## **K. FIRE**

**FIRE FLOW CALCULATIONS**  
**Lincoln Street Apartments**

**Project Name:** 9 Unit Townhomes  
**Project Address:** 2420 Lincoln Street  
Hollywood, FL  
**ZE Project #: 23-04**

**RE: Landscape Comment Responses  
9 Unit Townhomes – 2420 Lincoln Street  
Hollywood, FL 33020**

9 UNIT TOWNHOMES  
2420 LINCOLN ST.  
HOLLYWOOD, FL 33020  
**EXISTING TREE  
DISPOSITION PLAN**

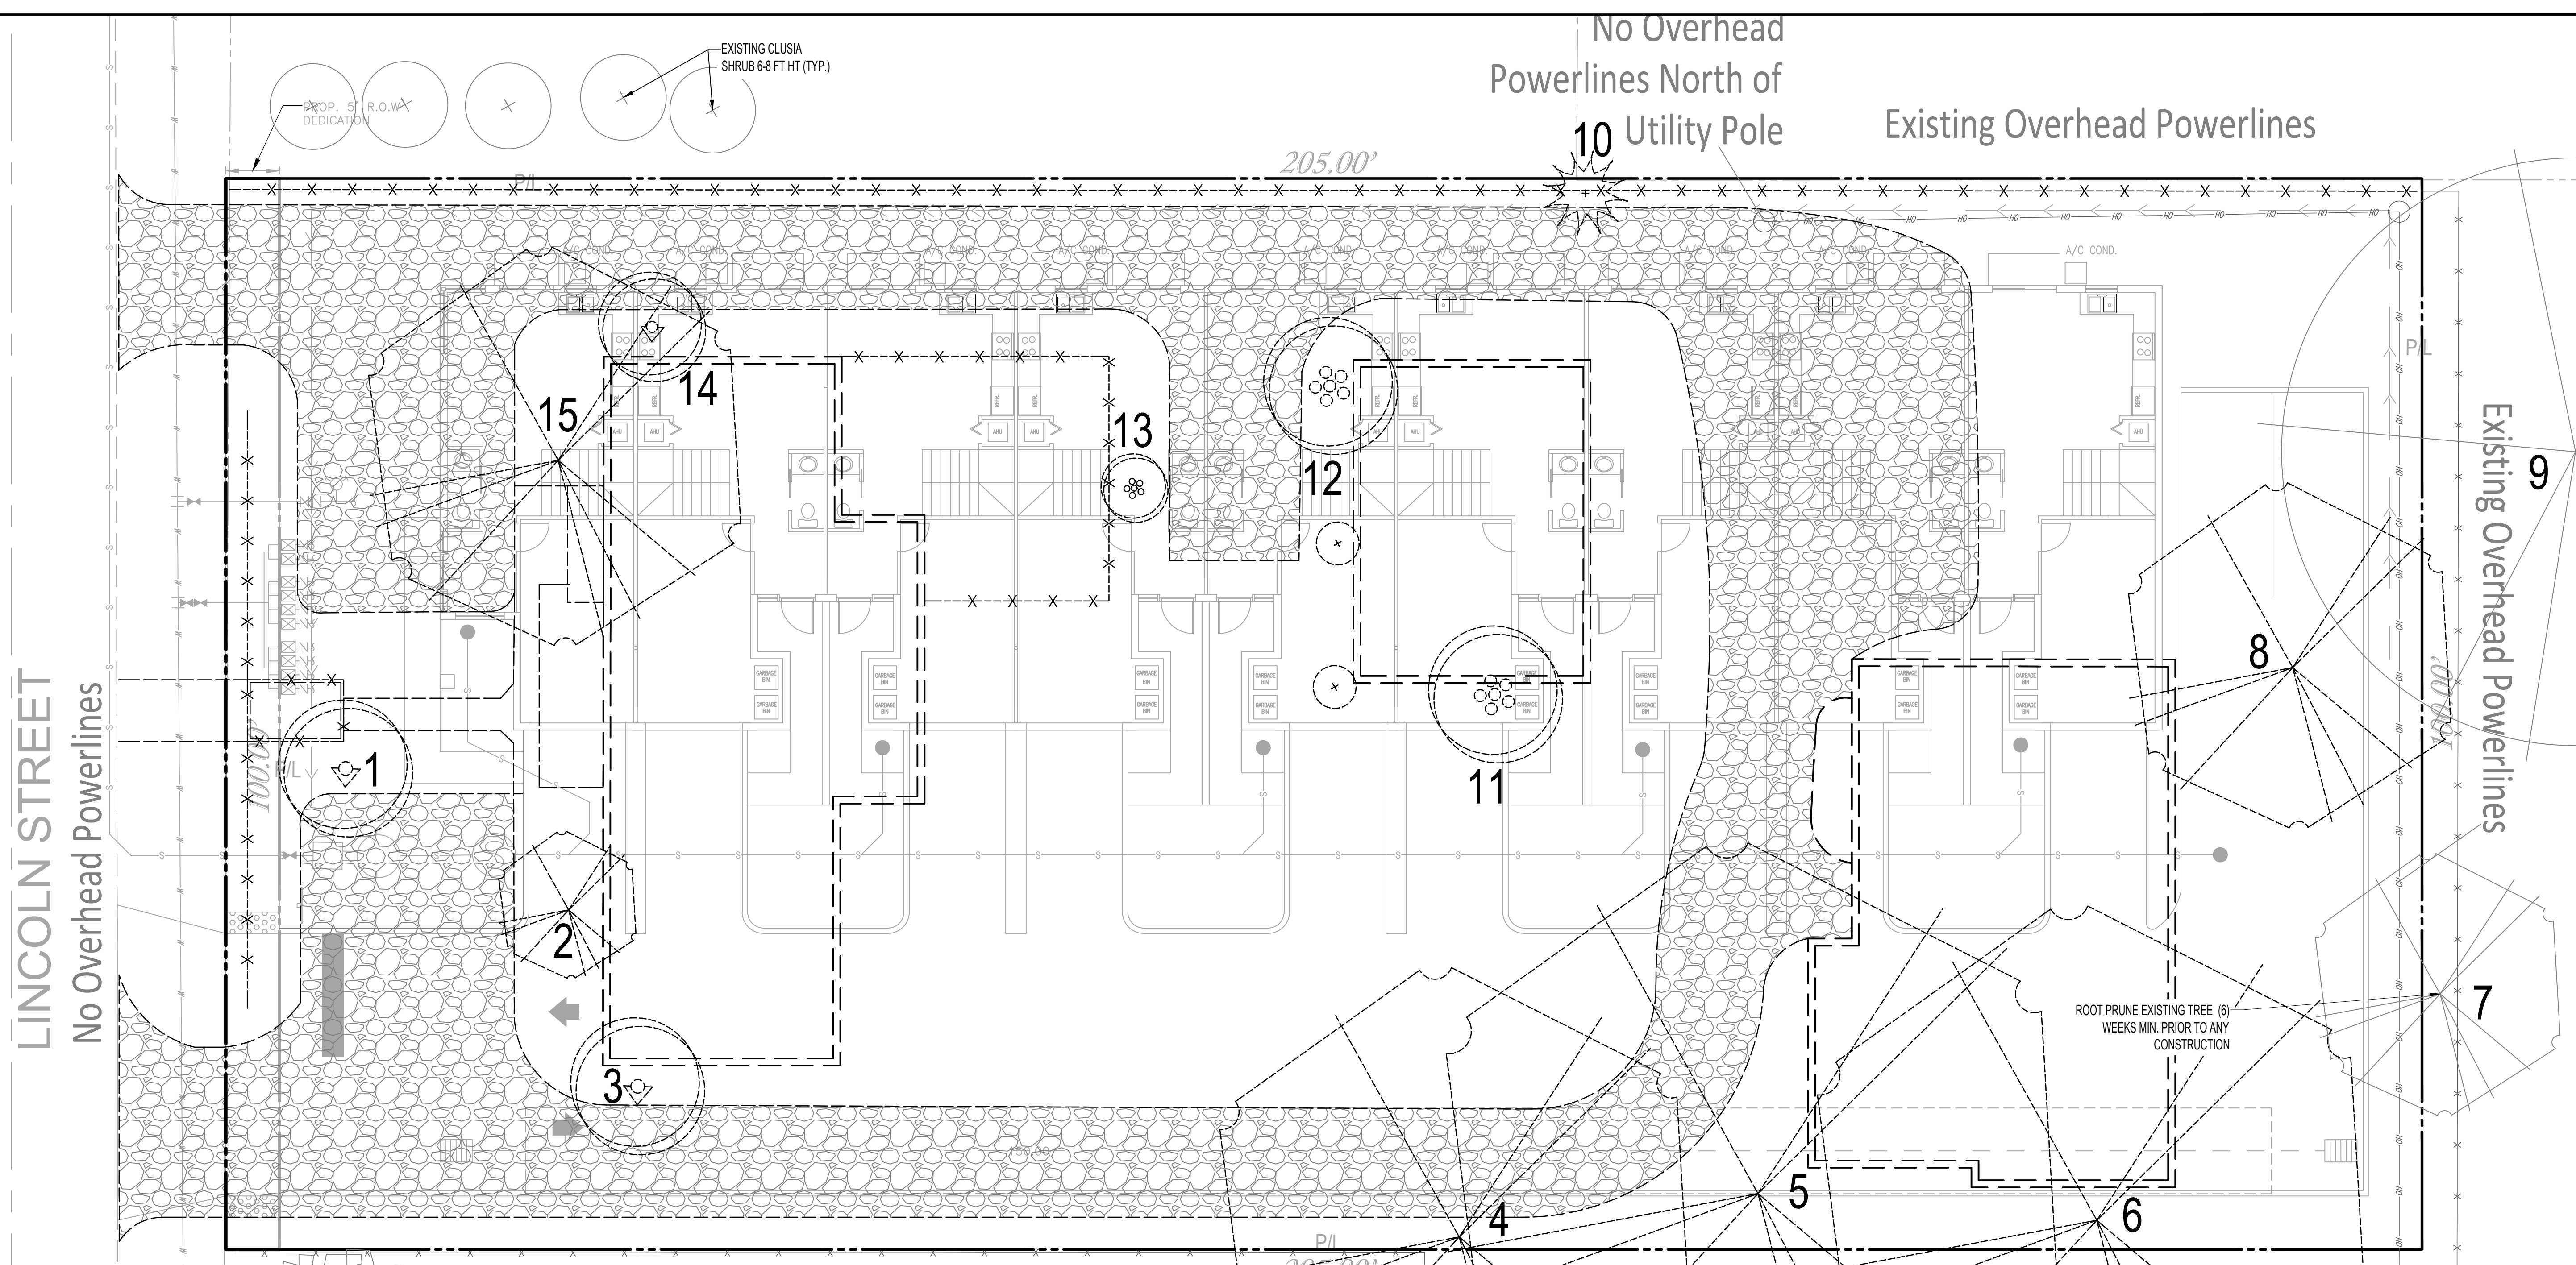
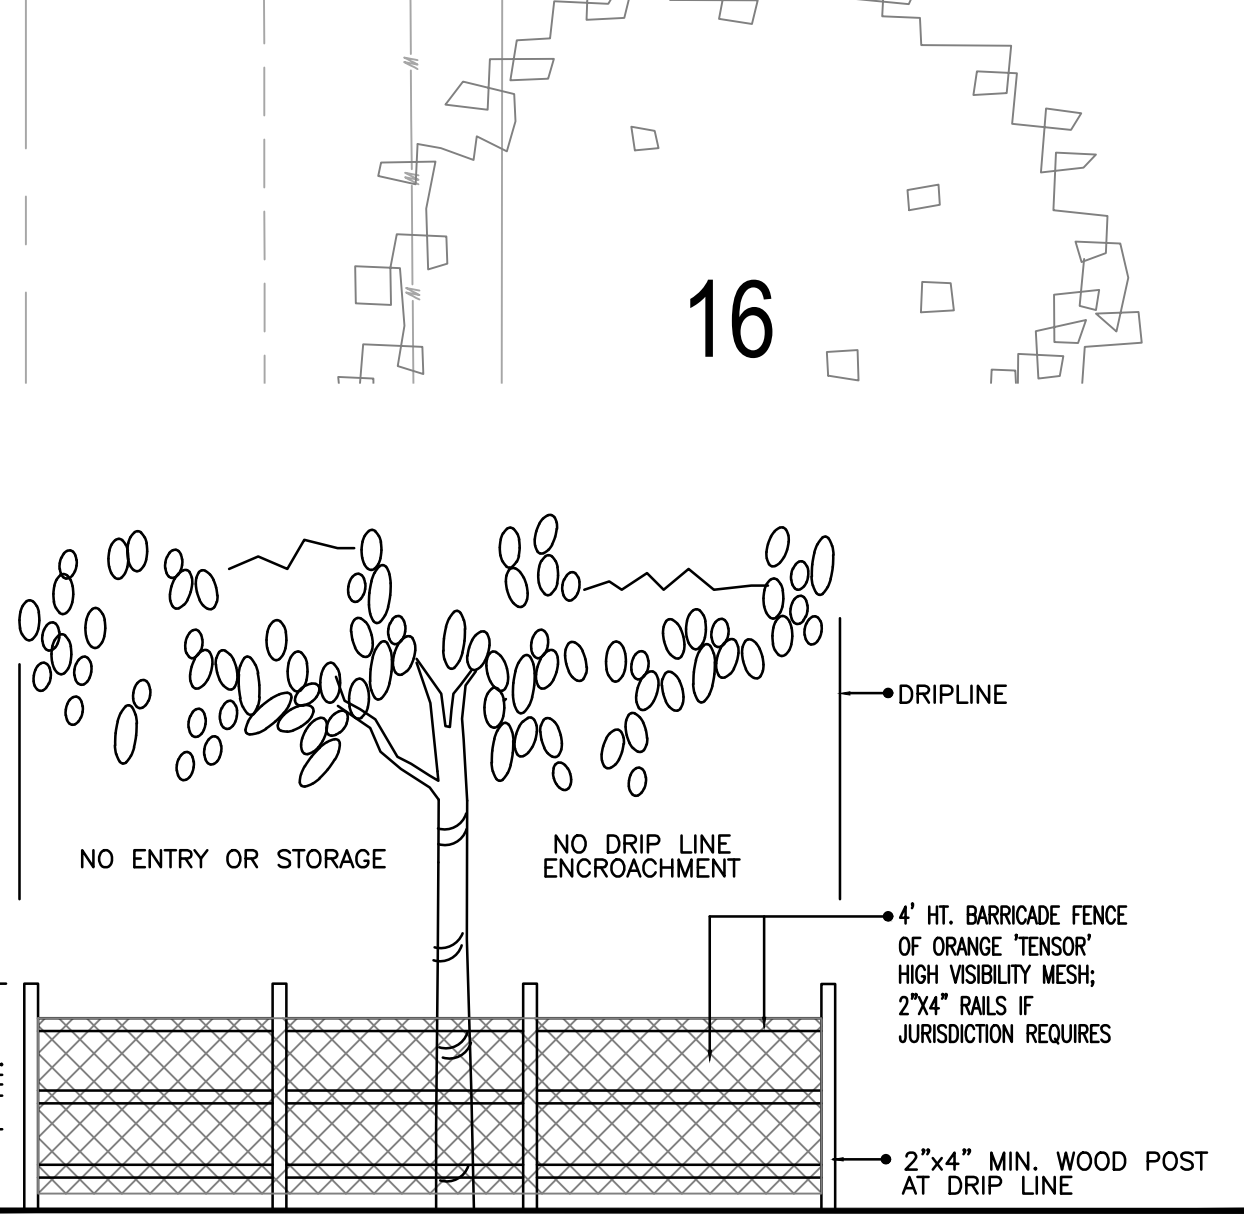
1. Revise mitigation chart: 4 palms are required to be mitigated.

**RESPONSE: A total of 5 existing Palms are proposed for removal. As such, 5 Palms are now included in the required Mitigation Calculations. See sheets L-1 Disposition Plan & Code Chart on sheet L-2 Landscape Plan.**

SHEET NUMBER:  
**L-2**

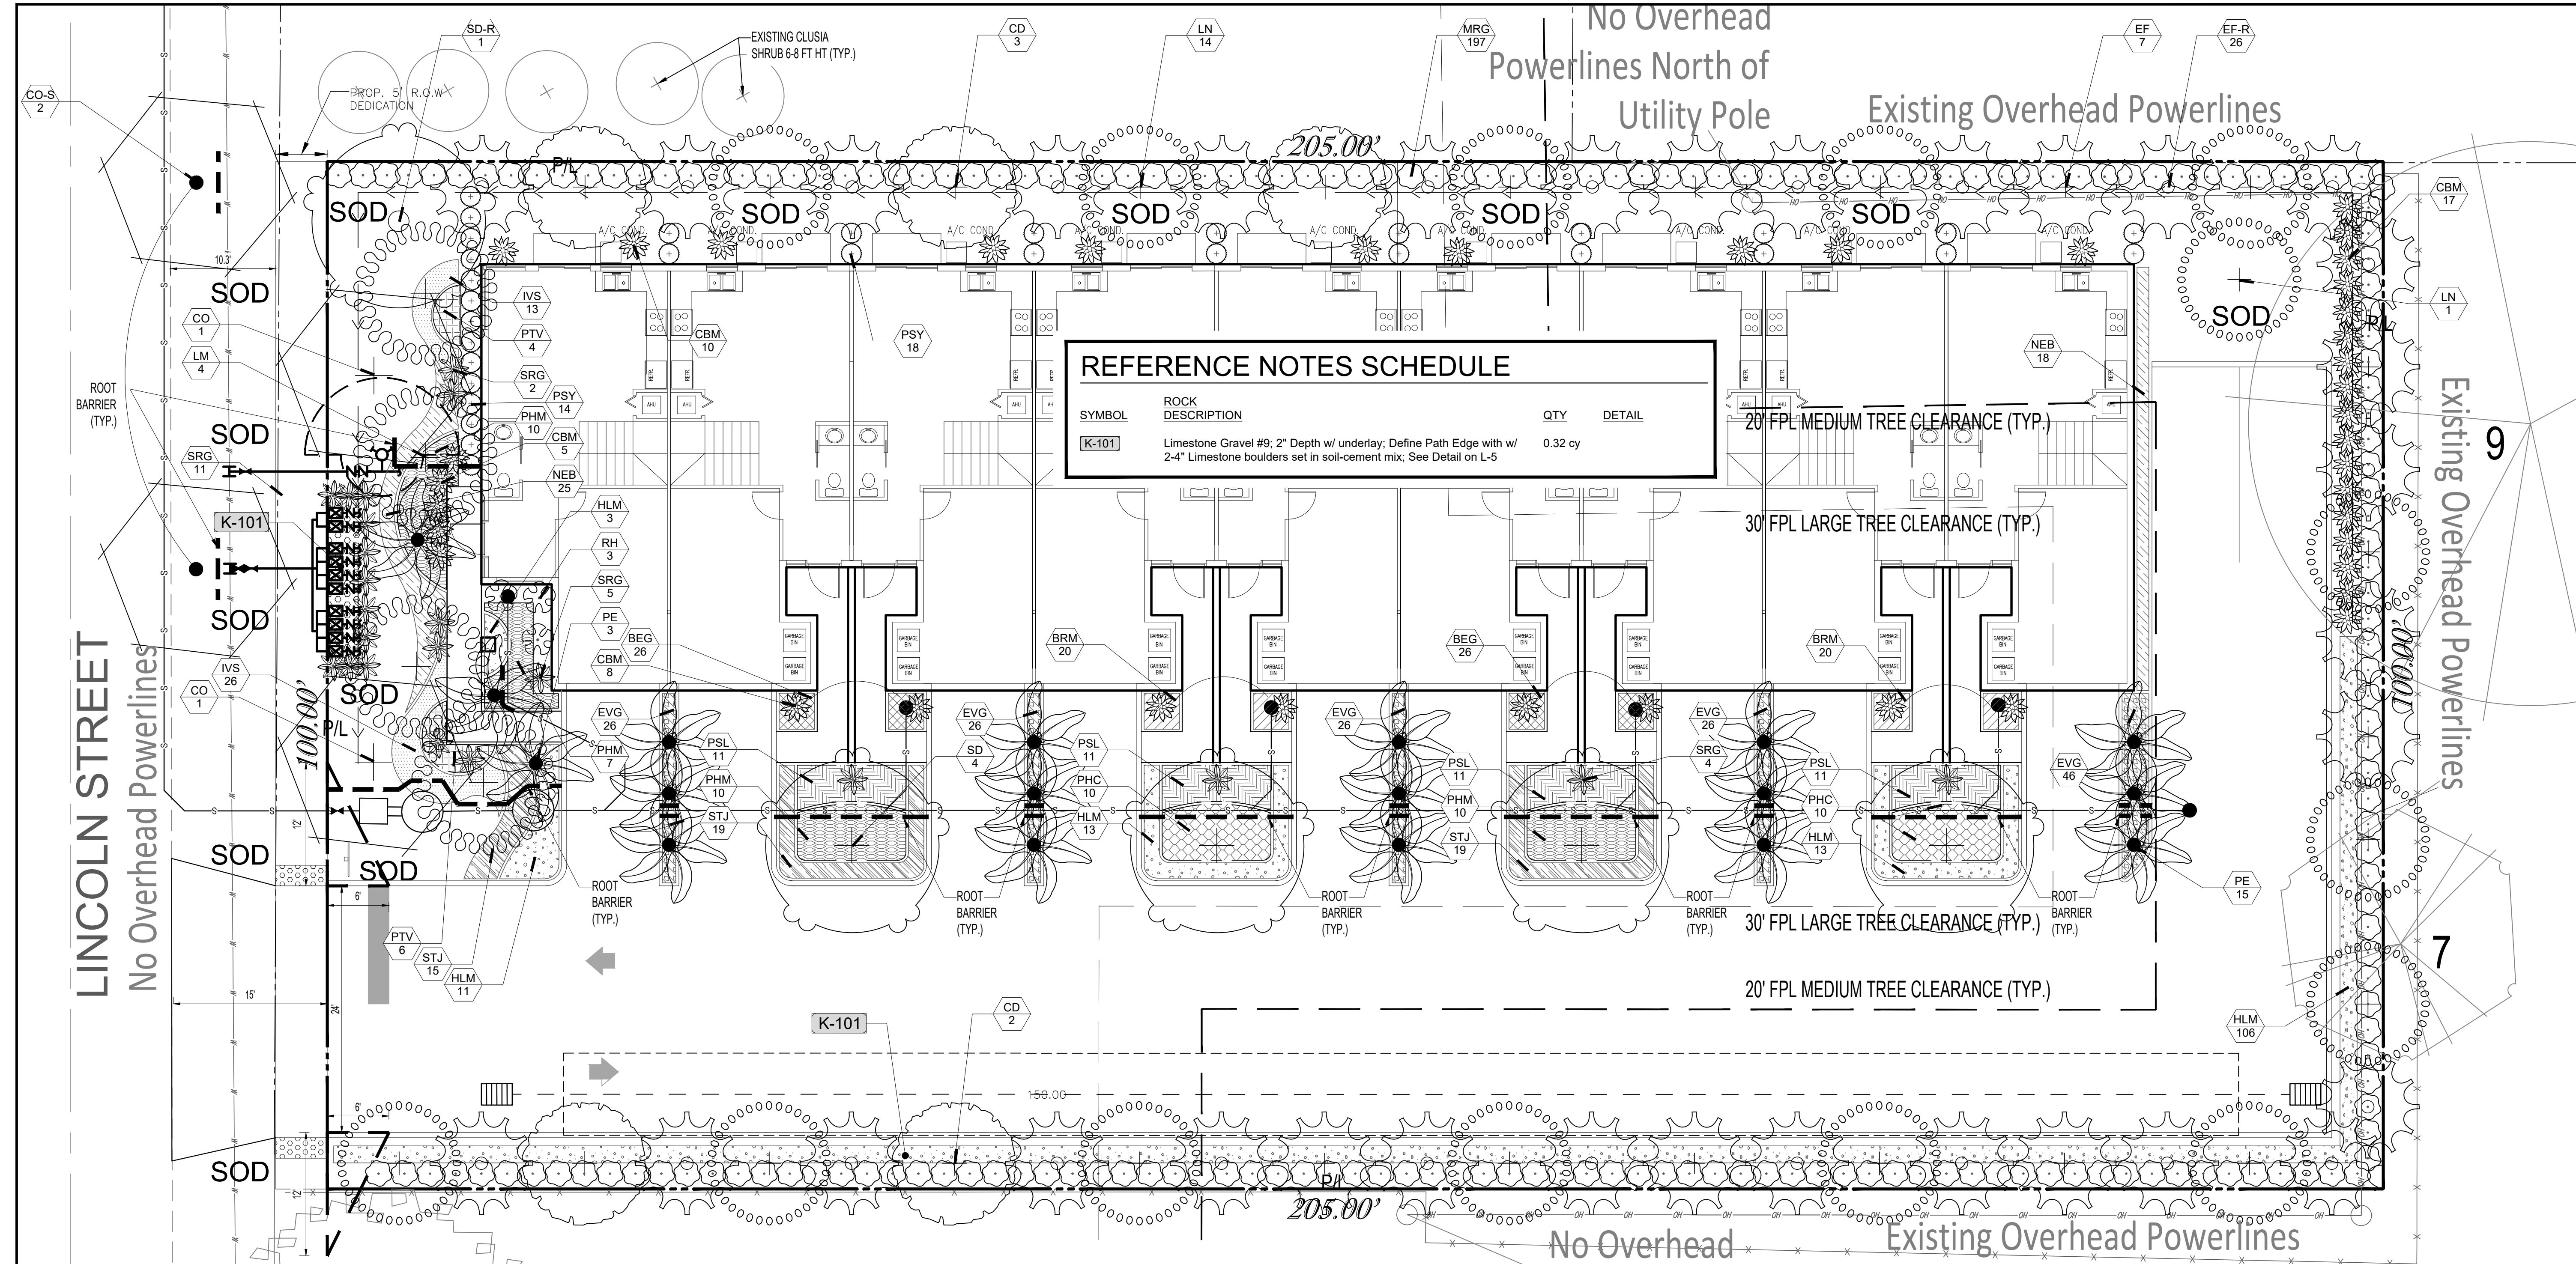
2. Revise mitigation chart: Multi trunk Wax Myrtle cannot be counted per trunk to meet mitigation requirements. Trees must be single trunk with a 2" dbh minimum. Revise counts and resubmit.

3. Remove mitigation payment amounts if that option is not being requested.

4. Minimum tree height for code is 12' ht. revise plant list as needed.

5. Provide sight triangles on plans at intersection of driveway and property line – Sec. 155.12 (d)

8. Add note: 100% irrigation coverage shall be provided.

**RESPONSE: Wax Myrtle is no longer proposed to meet mitigation requirements. See sheet L-2 Landscape Plan for revised Plant Schedule & proposed tree mitigation, including replacement DBH inches from proposed trees provided above Code minimum size of 2" DBH & also proposed 'Replacement Trees' as noted on the Plant Schedule.**

**RESPONSE: Mitigation has been revised. See sheets L-1 Disposition Plan & Code Chart on sheet L-2 Landscape Plan.**

**RESPONSE: Tree height has been revised to be 12 ft ht minimum. See Plant Schedule on sheet L-2 Landscape Plan.**

**RESPONSE: See Sight Triangles at the driveway on sheet L-2 Landscape Plan. Unobstructed cross visibility is provided in the required sight triangles at heights between 30 inches & 72 inches above finish grade.**

**RESPONSE: Note has been added to sheet L-2 Landscape Plan at the lower left hand corner. Note also exists on sheet IR-1 Irrigation Plan, General Irrigation Note #15.**
